Products: 533001 (5/8" bore) & 533002 (1/2" bore) - Heat Sink Fan Discs
Serial Range: N/A
Release Date: February 2018

Heat Sink Fan Disc

Disc Installed on Motor

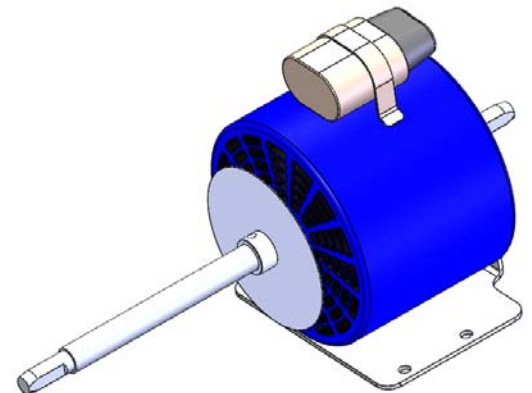
When replacing the convection fan motor it is important to also replace, or reuse, the heat sink fan disc. The disc helps dissipate the heat from the smoker's cabinet before it reaches the convection fan motor resulting in a longer life span for the motor. The disc will now ship with the convection fan motors listed below when a replacement motor is purchased. The disc will be shipped loose and should be installed with the flat of the disc facing the motor.
